NL-04-0946

Edwin I. Hatch Nuclear Plant Technical Specifications Revision Section 5.3.1-Unit Staff Qualifications

Marked-up Technical Specifications Pages

5.3 Unit Staff Qualifications

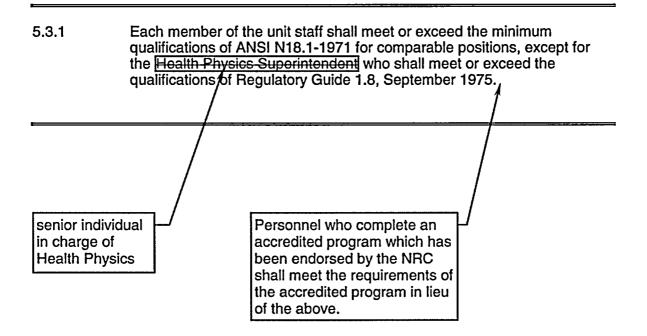
This request proposes to revise Administrative Controls Section 5.3.1 by removing the specific title reference to the Health Physics Superintendent, and replacing it with a more appropriate reference to the senior individual in charge of Health Physics. A statement is also being added to Section 5.3.1 to allow unit staff positions to be filled by personnel who complete an accredited program that has been endorsed by the Nuclear Regulatory Commission (NRC). These changes are needed to support SNC's ongoing initiatives to achieve fleet standardization to improve plant efficiencies. Accordingly, the proposed changes are consistent with the unit staff qualification requirements contained in SNC sister plants', Farley and Vogtle, Administrative Controls Technical Specifications. The proposed changes will reduce the regulatory burden of having to make future requests to revise Section 5.3.1 whenever a position title change is made. The proposed changes will also provide the flexibility to use an NRC accredited program for qualifying unit staff positions.

5.3.1 Each member of the unit staff shall meet or exceed the minimum qualifications of ANSI N18.1-1971 for comparable positions, except for the senior individual in charge of Health Physics who shall meet or exceed the qualifications of Regulatory Guide 1.8, September 1975. Personnel who complete an accredited program which has been endorsed by the NRC shall meet the requirements of the accredited program in lieu of the above.
